**PLANNED UNIT DEVELOPMENT  
& SUBDIVISION STAFF REPORT****Date: January 6, 2011****DEVELOPMENT NAME**

Goodwill Easter Seals Subdivision

**LOCATION**7431 Airport Boulevard  
(South side of Airport Boulevard, 350'± East of Portside Boulevard)**CITY COUNCIL****DISTRICT**

Planned Unit Development Approval to allow multiple building on a single building site, and Subdivision Approval to create a legal lot from a metes and bounds parcel.

# SITE PLAN

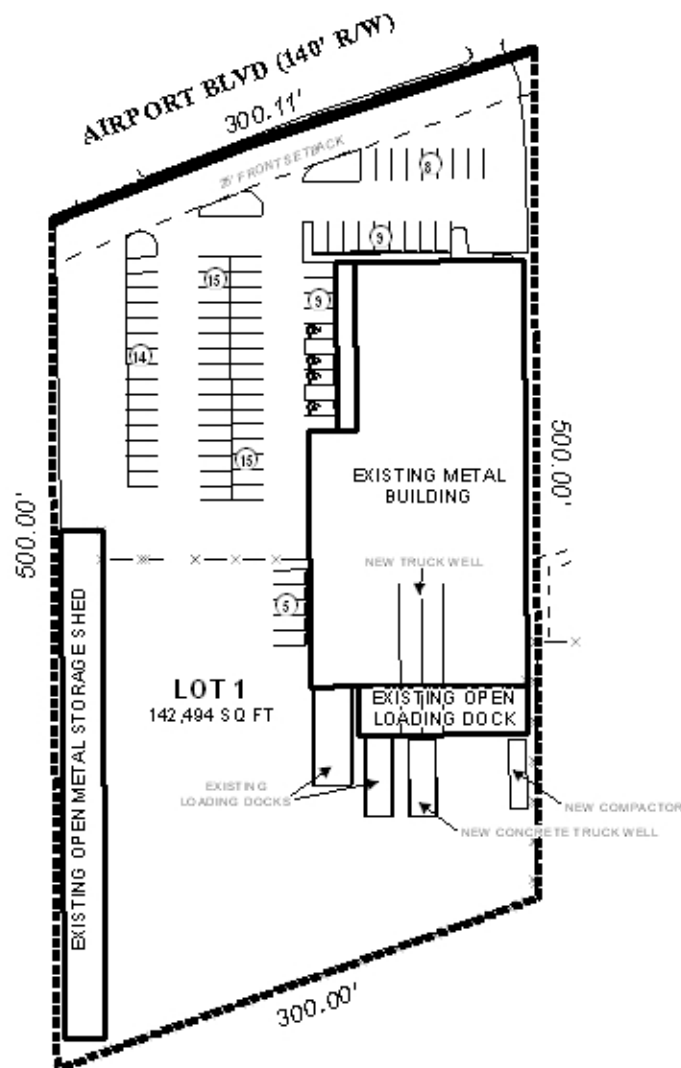
The plan illustrates the proposed location of the office and storage buildings, parking and existing landscaping. As illustrated on the site plan, no new landscaping or trees are provided; typically, for sites undergoing a change of occupancy or redevelopment, that has been vacant for several years and does not meet the landscaping and tree requirements of the Zoning Ordinance, staff has been adamant about the applicant providing some semblance of landscaping and trees. Since the applicant proposes more than the Zoning Ordinance requires for parking it would seem the applicant provide a landscape strip along Airport Boulevard to provide sufficient space to plant the required number of frontage trees. Therefore, a condition of approval requiring the provision of a ten foot wide landscaping strip along Airport Boulevard and to provide ten (10) heritage frontage trees within this strip would be sufficient landscaping and trees for the site.

Regarding the PUD, the site plan submitted indicates an existing 29,506 square foot retail/office/storage building requiring 43 parking spaces and an existing 7,304 square foot metal storage shed. The site plan submitted indicates all property line setbacks to be compliant, and site coverage is determined to be compliant due to the site coverage calculations given. As previously mentioned it should be noted that the site plan indicates that the existing site does not meet the landscaping requirements for total and frontage square footage.

Internal circulation, parking and areas for truck loading/unloading are indicated. The existing curb cuts to Airport Boulevard are shown to remain. Parking calculations are provided based on the square footage of each use of the buildings, the calculations are correct based on the proposed uses of the buildings.

No storm water detention area is indicated, but no verification is furnished that such would not be required.

A dumpster/compactor is depicted on the site plan; therefore, the provision of a six-foot high solid wooden fence should be provided and labeled on the revised site plan. Additionally, the site must provide sufficient buffering due to being adjacent to residential properties; therefore, the provision of a six-foot solid privacy fence along the site where adjacent to residential properties, should be required.

- 3) placement of a note on the site plan stating that the lot is limited to two (2) curb-cuts, with the size, design and location to be approved by Traffic Engineering and in compliance with AASHTO standards;

- 4) the labeling of the lot with its size in square feet;
- 5) the depiction of a ten foot wide landscaping strip along Airport Boulevard with ten (10) heritage frontage trees within this strip to be coordinated with Urban Development; and

- 6) provision of a revised PUD site plan prior to the signing of the Final Plat.
